## 12 Vida Place Howick 2014

# Certificate of Acceptance

**Re: Unauthorised works at 12 Vida Pl, Howick**

UNAUTHORISED BATHROOM & CLOAKROOM AT 12 VIDA PL. HOWICK

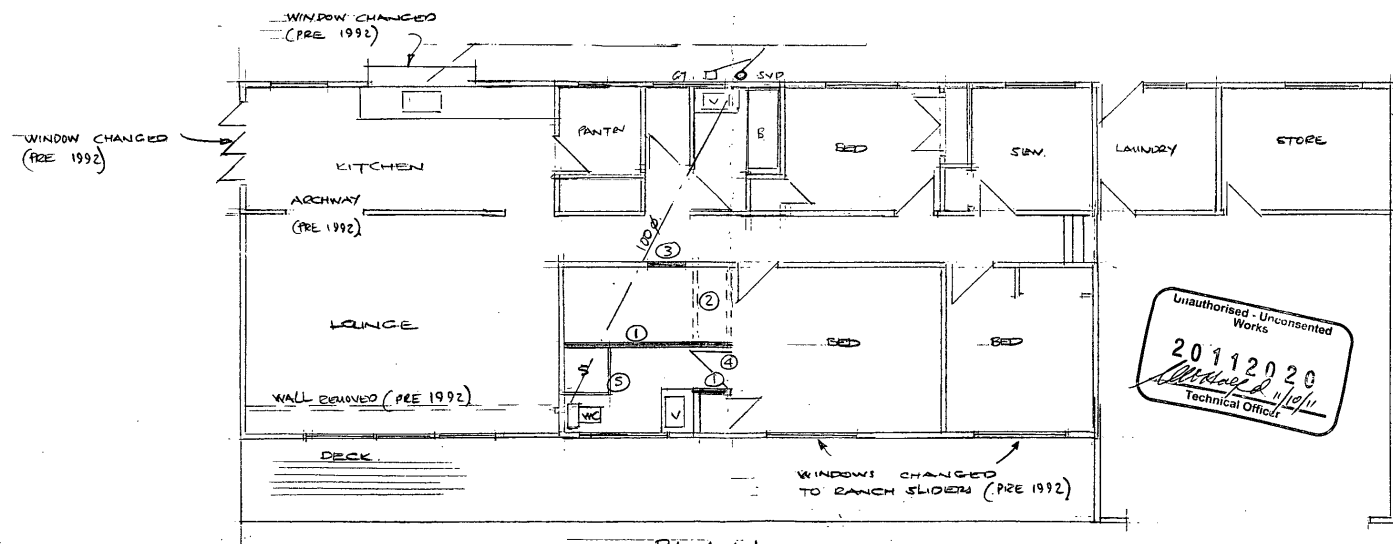
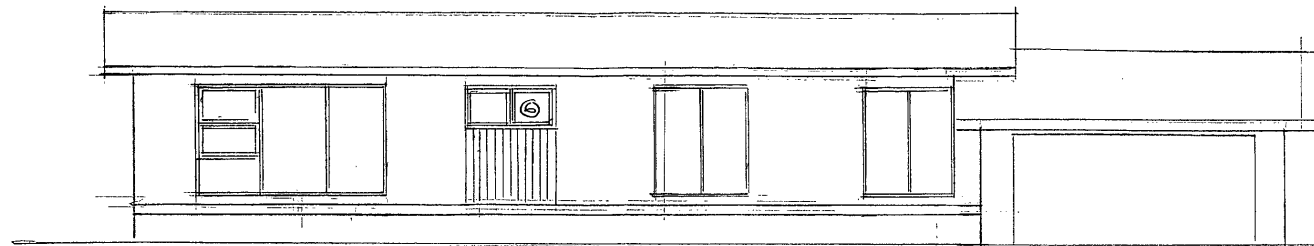
1. Construct internal wall to divide bedroom into two areas
2. Remove wardrobe walls
3. Infill doorway
4. Form new doorway
5. Install sanitary fittings
6. Replace ranch slider with window

It is recommended that the works be approved and a Certificate of Acceptance be issued based on my inspection, plans, analysis sheets and report
